APPLICATION NO.	FILING DATE	FIRST NAMED INVENTOR	ATTORNEY DOCKET NO.	CONFIRMATION NO.
10/042,057	01/07/2002	Manfred Baldauf	GR 99 P 8088	4485
24131	7590	05/20/2005	EXAMINER	
LERNER AND GREENBERG, PA P O BOX 2480 HOLLYWOOD, FL 33022-2480			WILLS, MONIQUE M	
			ART UNIT	PAPER NUMBER
			1746	
DATE MAILED: 05/20/2005

Office Action Summary

This Office Action is responsive to the Amendment filed Feb. 24, 2005. All rejections of record have been maintained and actions are made Final. A brief reiteration of the rejections is recited below.

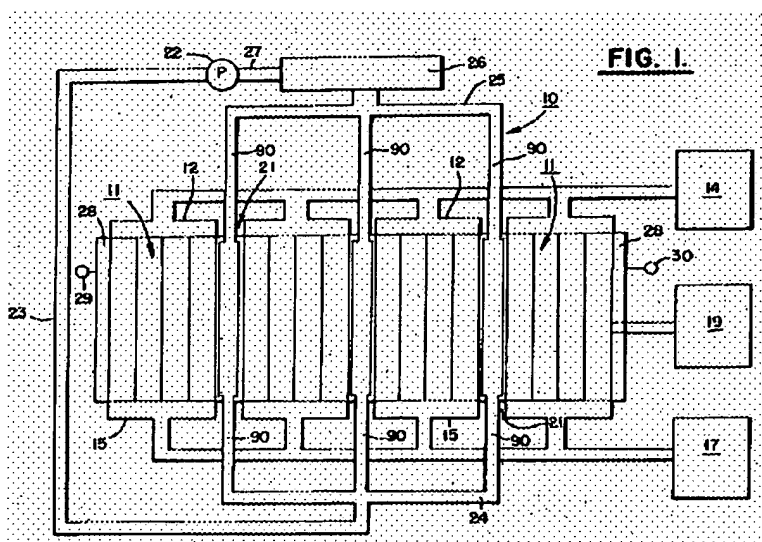
The reference is silent to at least two of the subsystems having respective cooling circuits, configured to be connected by series or parallel.

However, Wittel teaches that it is conventional to employ subsystems having respective cooling circuits in series/parallel as illustrated in Figure

in order to maximize heat transfer from the fuel cell stack to the coolant without undue manufacturing and assembly tolerances and to avoid shunt currents without the need for additional electrical isolation from adjacent cells of the fuel cell stack. See column 3, lines 5-25.

Therefore, it would have been obvious to one of ordinary skill in the art at the time the instant invention was made to employ the cooling circuits of Wittel in the fuel cell stack of Einhart, in order to maximize heat transfer from the fuel cell stack to the coolant without undue manufacturing and assembly tolerances and to avoid shunt currents without the need for additional electrical isolation from adjacent cells of the fuel cell stack.

However, Wittel teaches that it is conventional to employ subsystems having respective cooling circuits in series/parallel illustrated as in Figure 1:

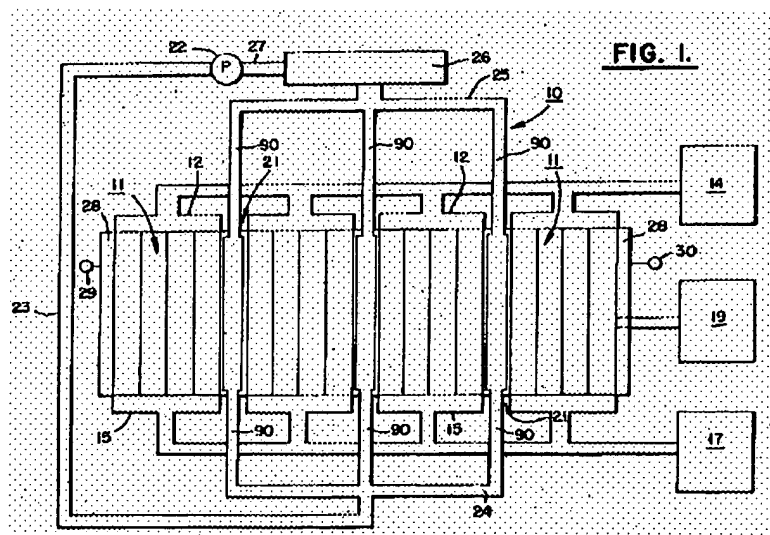
The reference is silent to at least two of the subsystems having respective cooling circuits, configured to be connected by series or parallel.

in order to maximize heat transfer from the fuel cell stack to the coolant without undue manufacturing and assembly tolerances and to avoid shunt currents without the need for additional electrical isolation from adjacent cells of the fuel cell stack. See column 3, lines 5-25.

Therefore, it would have been obvious to one of ordinary skill in the art at the time the instant invention was made to employ the cooling circuits of Wittel in the fuel cell stack of Barton, in order to maximize heat transfer from the fuel cell stack to the coolant without undue manufacturing and assembly
